**UN Regulation No. 92 (Replacement Exhaust Silencing Systems for Motorcycles)**

**Informal document to amend ECE-TRANS-WP29-GRBP-2024/21**

**Proposal for a ~~Supplement 1 to the 02~~ **the 03** series of amendments to UN Regulation No. 92**

**Submitted by the experts from Germany, the Kingdom of the Netherlands, Switzerland, the United Kingdom of Great Britain and Northern Ireland and the European Commission**

Figure 1: Exhaust silencer

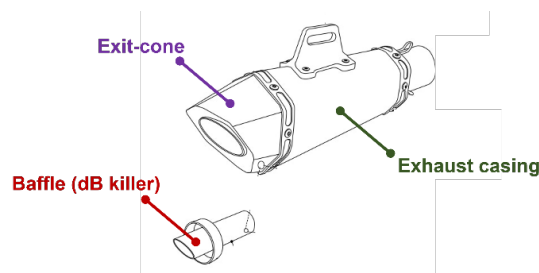
"2.8. **“Exit-cone”** means the final part of the exhaust silencing system outlet through which exhaust gases exit into the air (see figure 1).

Annex 3, paragraph 4, amend to read:

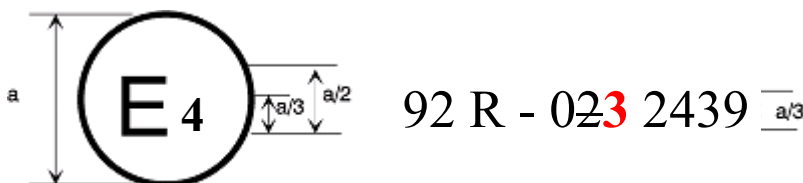
- "4. Before the system is tested in accordance with paragraph 6.2. of this UN Regulation it shall be put into a normal state for road use by one of the conditioning methods in accordance with and as described in paragraph 5.1.4. of Annex 3 of UN Regulations ~~Nos. Nos~~**Numbers** 9 or 63 or in paragraph 1.3. of Annex 5 of UN Regulation ~~No. Number~~**o** 41, whatever is applicable."
